r: SEMICONDUCTOR DEVICE AND

METHOD FOR MANUFACTURING SAME

PRELIMINARY AMENDMENT

REQUEST FOR APPROVAL OF DRAWING CHANGES

FIG. 9

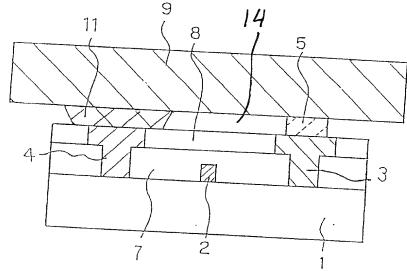
-- The active element and the package, prepared as described above, are positioned so that the source electrode 4 of the active element faces/abuts to the Au plating 11 on the heat sink 9 of the package, and the active element and the package are bonded to each other by thermal pressure bonding for mounting, leaving a void 14 between the Au plating 11 and the Aluminum nitride 5, as show in Fig. 9.--

--The active element and the package, prepared as described above, are positioned so that the source electrode 4 of the active element faces the Au plating 11 on the heat sink 9 of the package, and so that the drain electrode 3 faces the aluminum nitride 5, leaving a void 14 between the Au plating and the aluminum nitride 5. In this state, the active element and the package are bonded to each other by thermal pressure bonding for mounting, as shown in Fig. 9. —

The "void" which is the basis for the amendments to the claims and the specification, is formed by a space between the Au conductor, which covers the source electrode and the aluminum nitride insulator, which covers the drain electrode. On page 13 of the specification the steps for forming the aluminum nitride insulator on the drain electrode of the active element are recited. Initially, the second insulating layer is etched back to expose the source and drain electrodes. Then aluminum nitride is deposited over the entire chip. The aluminum nitride is then etched so that it only covers the drain electrode. Subsequently there are no further insulating layers deposited on the active element.

Next, an Au plating is applied to the heat sink, and the heat sink Au plating package is then bonded to the active element. As shown in figures 8 and 9 the Au plating (11) has distinctive boundaries. The Au plating is not shown as contacting the aluminum nitride, nor is the plating shown as expanding beyond the surface of the source electrode which it covers. Additionally, in Figure 8 of the application there is an overheard view of the package where the gold plating is shown as approximately the same width as the source electrode which it will have to cover. Accordingly, if the Au plating is approximately the same width

Please approve the changes to figures 9 and 11 of the attached drawings (2
